CROSSROADS MIXED USE FILING NO. 2

GRADING & EROSION CONTROL PLANS

JULY 2023

V4_GEC Plan Comments.pdf Markup Summary

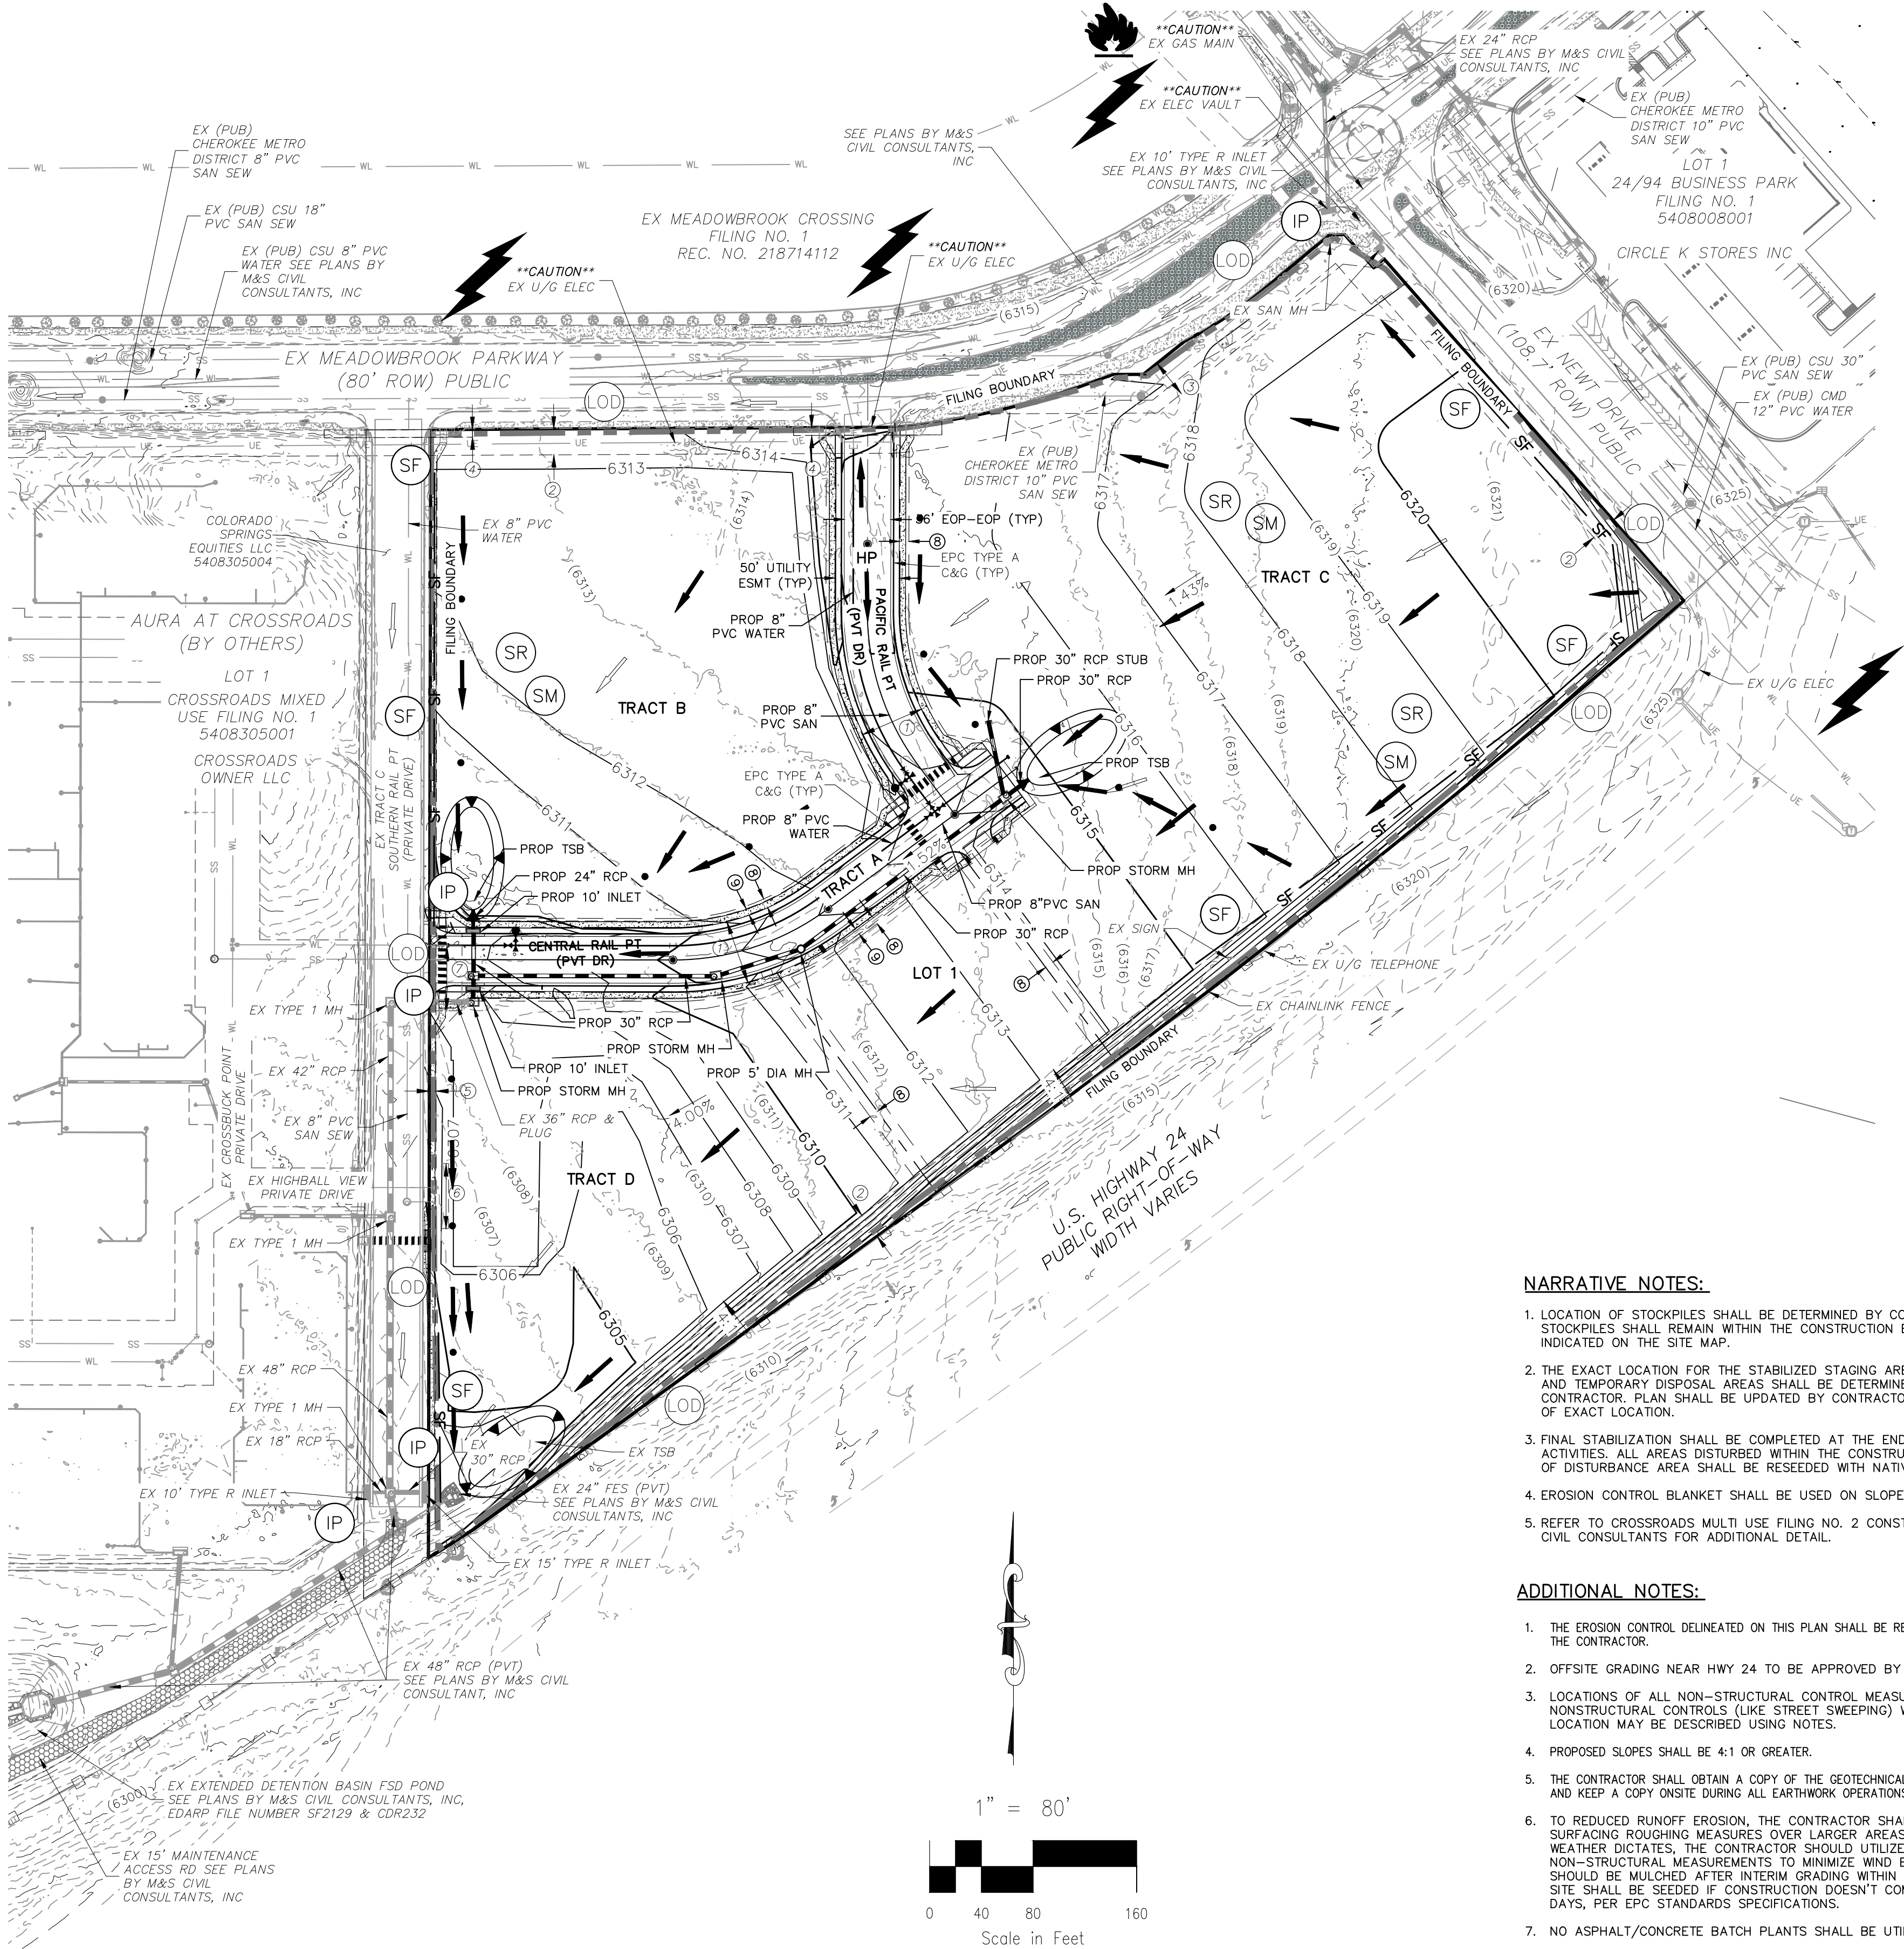
It appears that the sidewalk layer and cross walk stripping may have been turned on inadvertently for this interim condition. Revise as needed

THE SIDEWALK LAYER AND CROSS WALK STRIPPING HAVE BEEN TURNED OFF FOR THIS INTERIM CONDITION.
